REGULAR MEETING AGENDA

**Tuesday, July 23, 2024
6:30 P.M.**

1. CALL TO ORDER
2. ROLL CALL
3. APPROVAL OF THE MARCH 26, 2024, REGULAR MEETING MINUTES
4. APPROVAL OF AGENDA
5. PUBLIC HEARINGS
 - A. **SPECIAL LAND USE – WHITE WATER CAR WASH – 2675 WASHTENAW AVENUE – PACEL K-11-06-304-004** – TO CONSIDER THE SPECIAL CONDITIONAL USE PERMIT APPLICATION OF EROP, LLC TO PERMIT THE CONSTRUCTION OF A 6,820 SQ. FT. CAR WASH FOR A 1.55-ACRE SITE ZONED RC, REGIONAL CORRIDOR, WITH A PROPOSED SITE TYPE C DESIGNATION.

6. OLD BUSINESS
7. NEW BUSINESS
 - A. **PRELIMINARY SITE PLAN – WHITE WATER CAR WASH – 2675 WASHTENAW AVENUE – PACEL K-11-06-304-004** – TO CONSIDER THE PRELIMINARY SITE PLAN APPLICATION OF EROP, LLC TO PERMIT THE CONSTRUCTION OF A 6,820 SQ. FT. CAR WASH FOR A 1.55-ACRE SITE ZONED RC, REGIONAL CORRIDOR, WITH A PROPOSED SITE TYPE C DESIGNATION.

DRAWING:
C-4

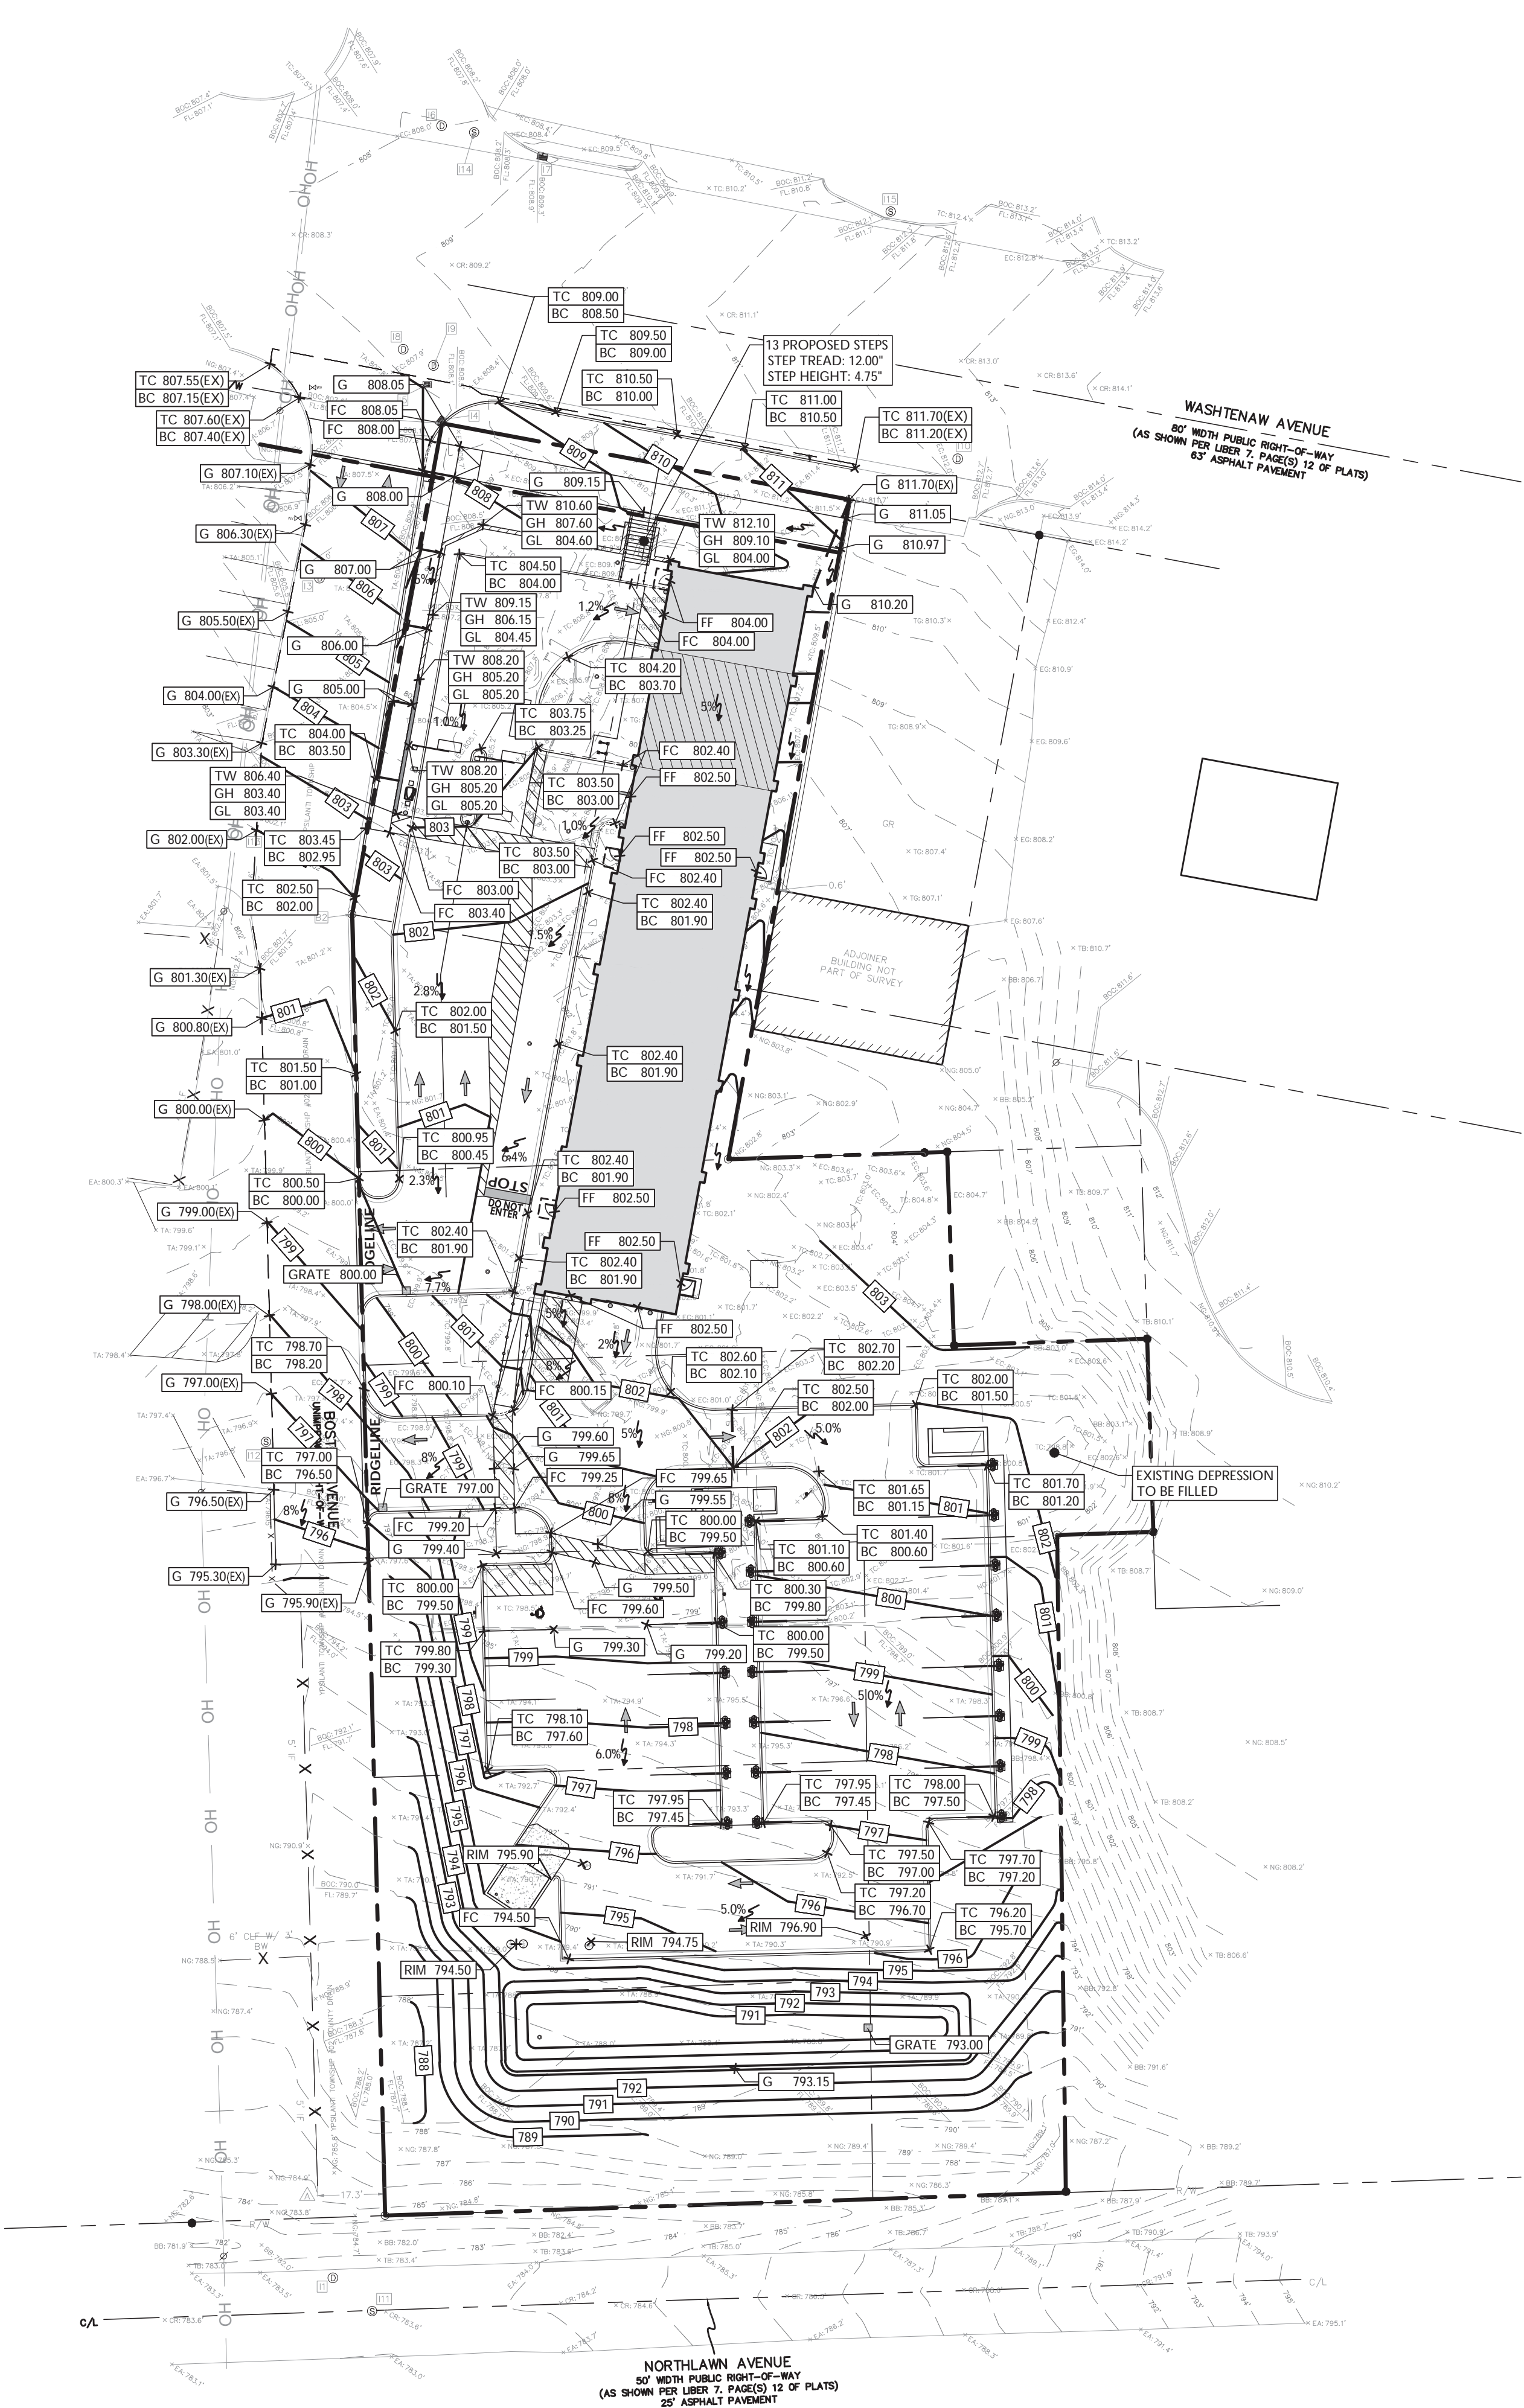
4. The YTD #02 must be identified on every plan sheet where it is depicted.
5. The call outs on the grading plan (plan sheet C-4) cover up structure labels and other information. Please revise for clarity.

TITLE:
DRAINAGE AREA MAPS

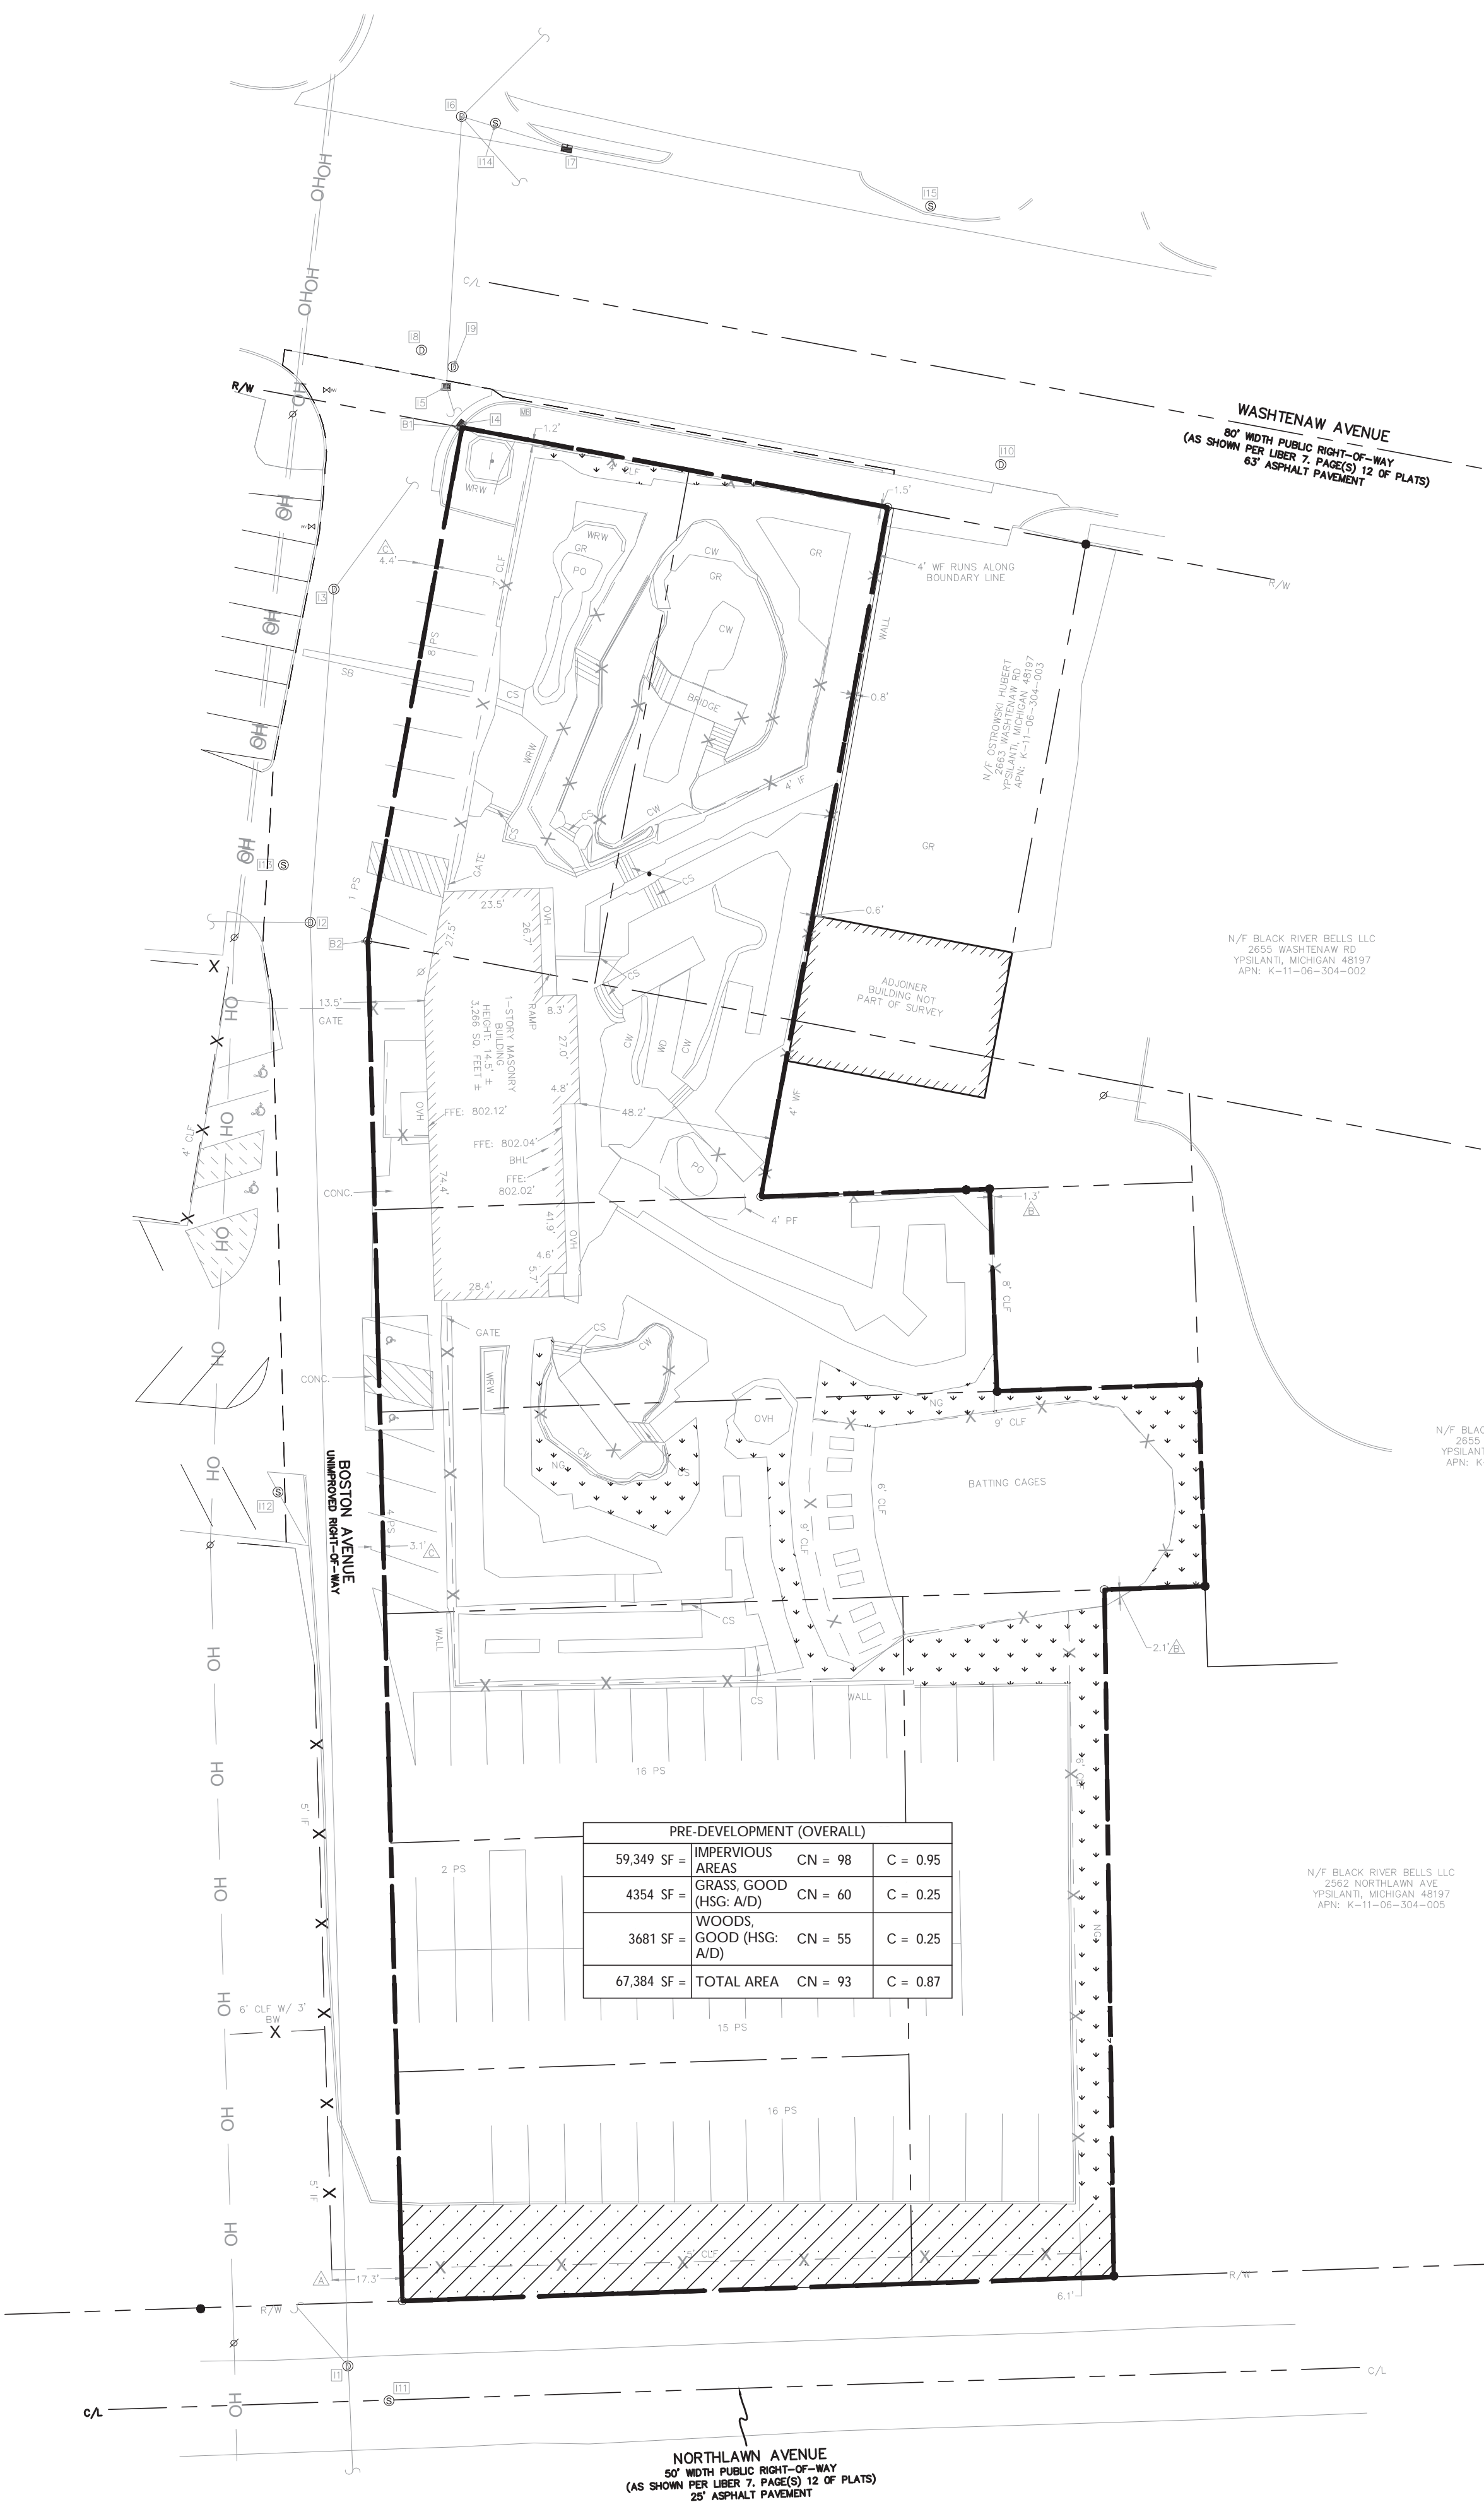
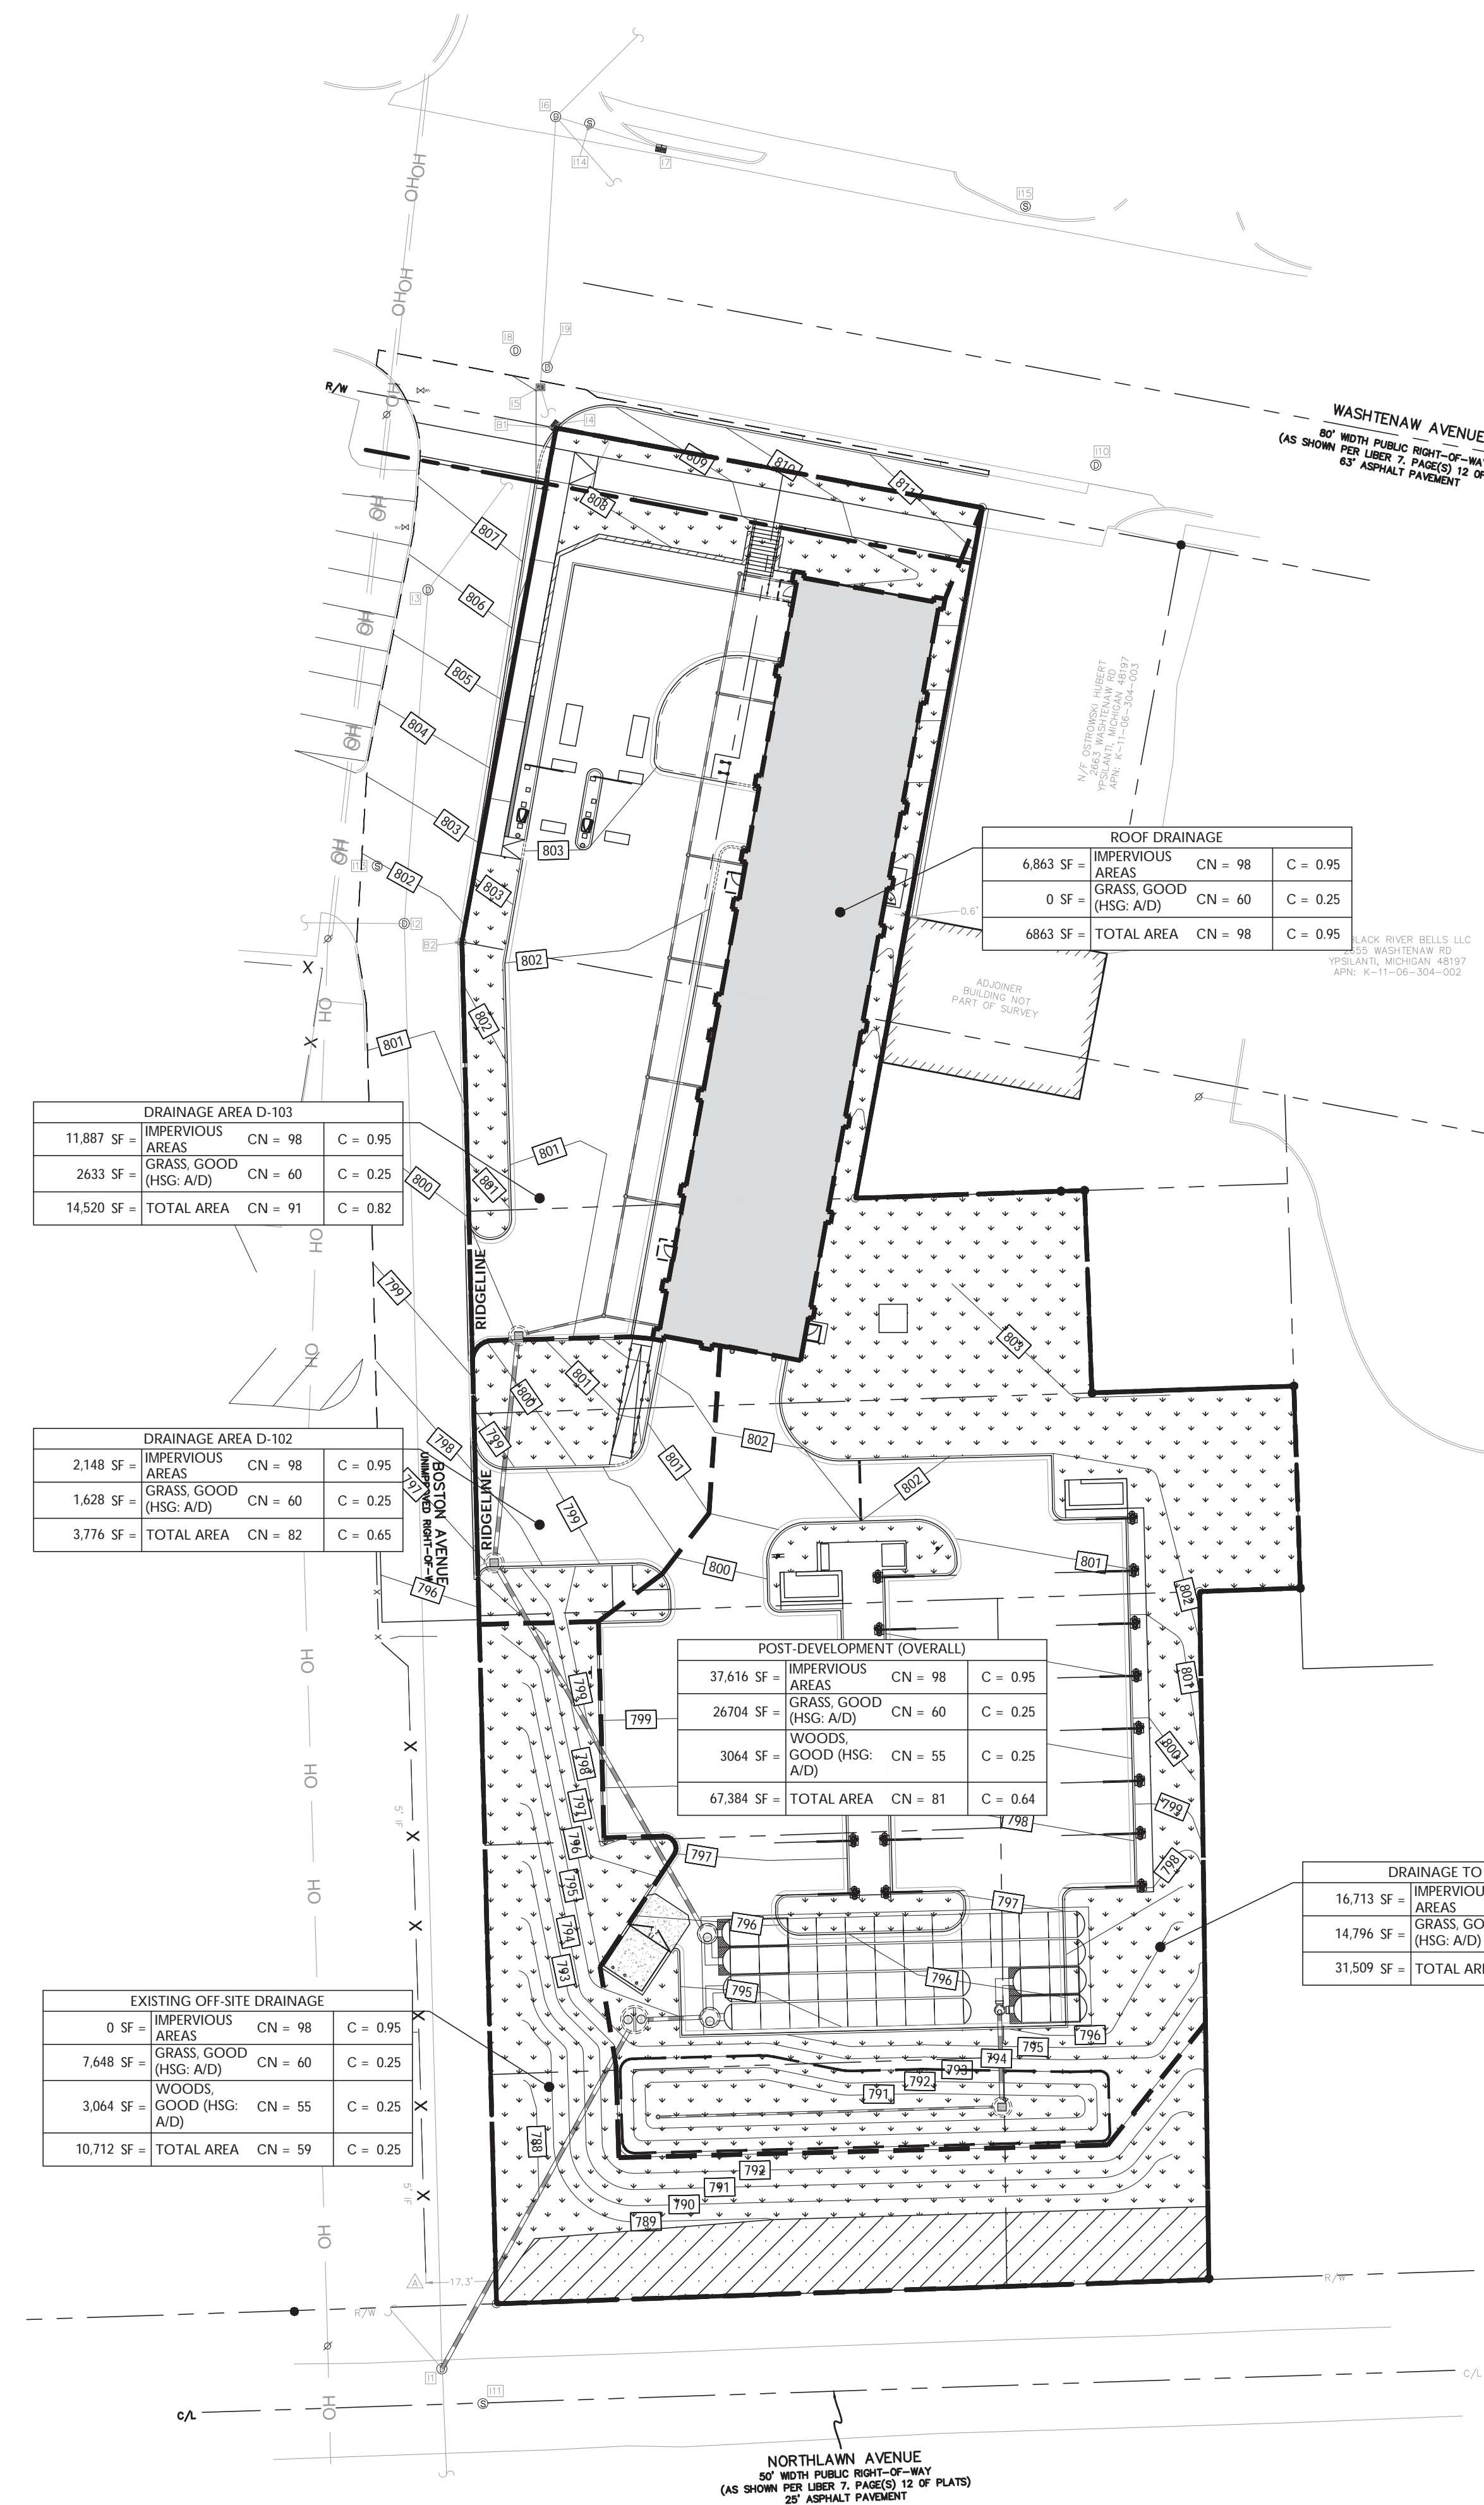
9. The applicant shall adjust the Drainage Area callouts (Sheet C-6) as one of them is currently cutoff.
10. The applicant shall verify the ground/rim elevation of Structure EX-1 as there appears to be a discrepancy between the profile view (Sheet C-17) and the plan view (Sheet C-5).

6. The applicant shall provide the C-factors for the proposed drainage areas (Sheet C-6).

Stonefield Response: C-factors have been added to the drainage areas on Sheet C-6.
